**Subject:** K/S 5500 Series Wheelchair Lifts  
**Applicable Products:** S55XX and K55XX Series Products  
**Effectivity:** ALL Units Produced Prior to March 2007 with Serial Numbers 212952 or Lower

**FIGURE 4: CHECK FOR VERTICAL ARM DEFORMATION**

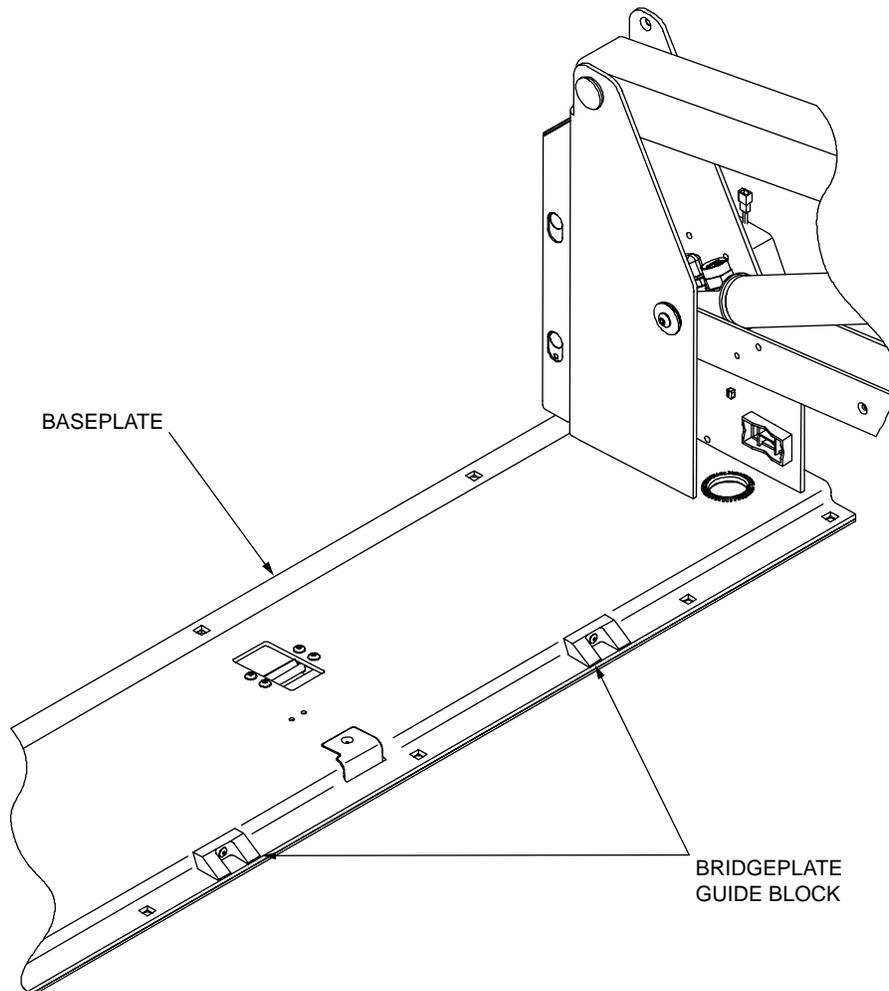
5. Use a straightedge or ruler to visually verify if the vertical arms have any deformation by placing straightedge or ruler to the left or right side of the vertical arms, as shown in **Figure 4**.

**Note:** There is no deformation of the vertical arms if there is no gap found between the straightedge or ruler and the vertical arms. If there is a gap present and deformation is found between the straightedge or ruler and the vertical arms, contact a Ricon authorized dealer for service.

**FIGURE 1: BRIDGEPLATE GUIDE BLOCK**

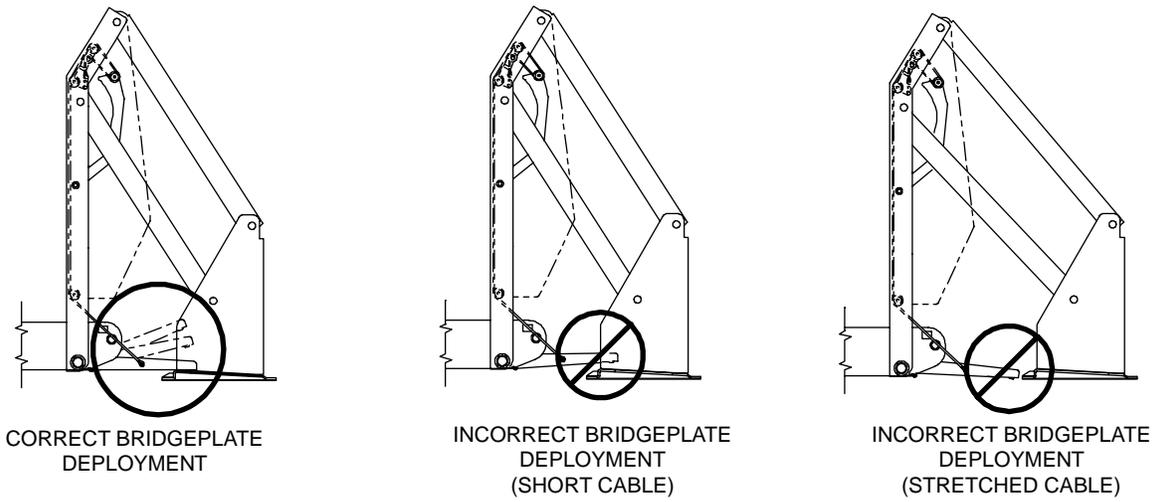
1. Inspect the wheelchair lift to ensure the bridgeplate guide blocks are installed on the baseplate as shown in **Figure 1**.
2. If the bridgeplate guide blocks are not present then follow installation instructions (32ii386e) for Installation of Guide Blocks Kit (P/N 35708).
3. Raise the wheelchair lift to vehicle floor level to verify proper bridgeplate deployment timing as shown in **Figure 2**.

**FIGURE 2: BRIDGEPLATE DEPLOYMENT TIMING**

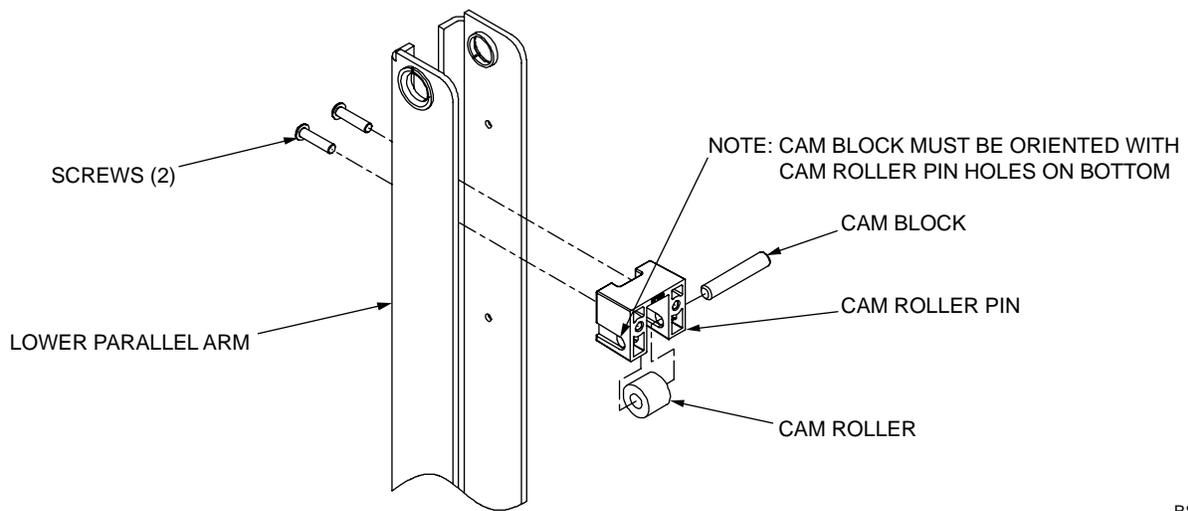
**Note:** If timed properly, the bridgeplate should contact the top of the baseplate when the bridgeplate approaches its fully deployed position. If the bridgeplate deploys pre-maturely, the bridgeplate deployment cables may be too long or stretched and will create contact with bridgeplate the front edge of the baseplate as shown in **Figure 2**.

4. If the bridgeplate deployment cables are too long or stretched then follow installation instructions (32ii419e) for Cable Assembly with Block Retrofit Kit (P/N 21813).

**FIGURE 3: CAM BLOCK INSTALLATION**

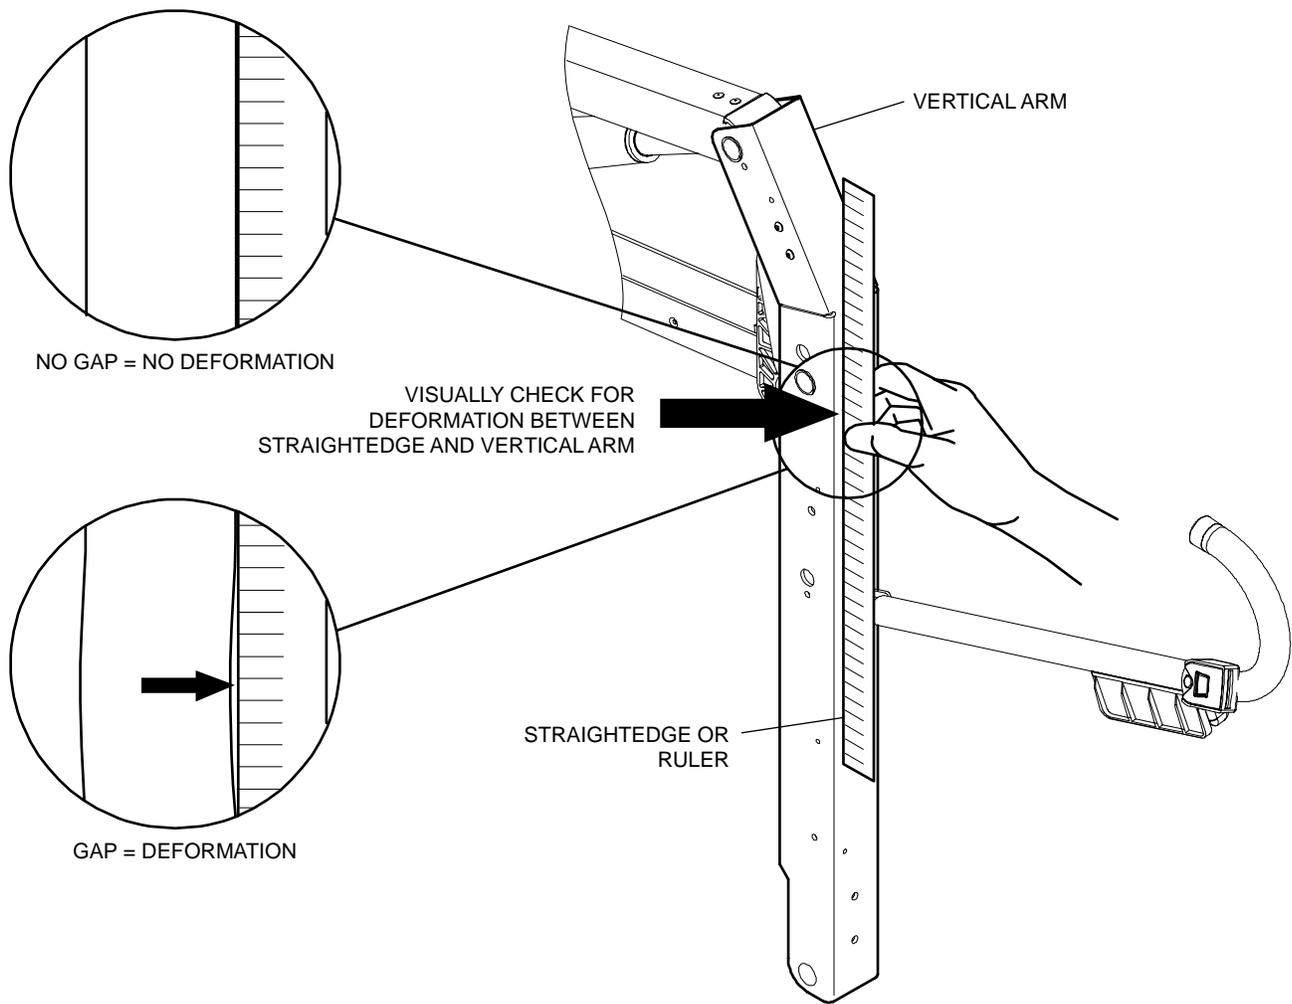
**Note:** Cam block (P/N 37729) must be installed as shown in **Figure 3** to ensure that the bridgeplate deploys properly onto baseplate. Note the orientation of the cam block.
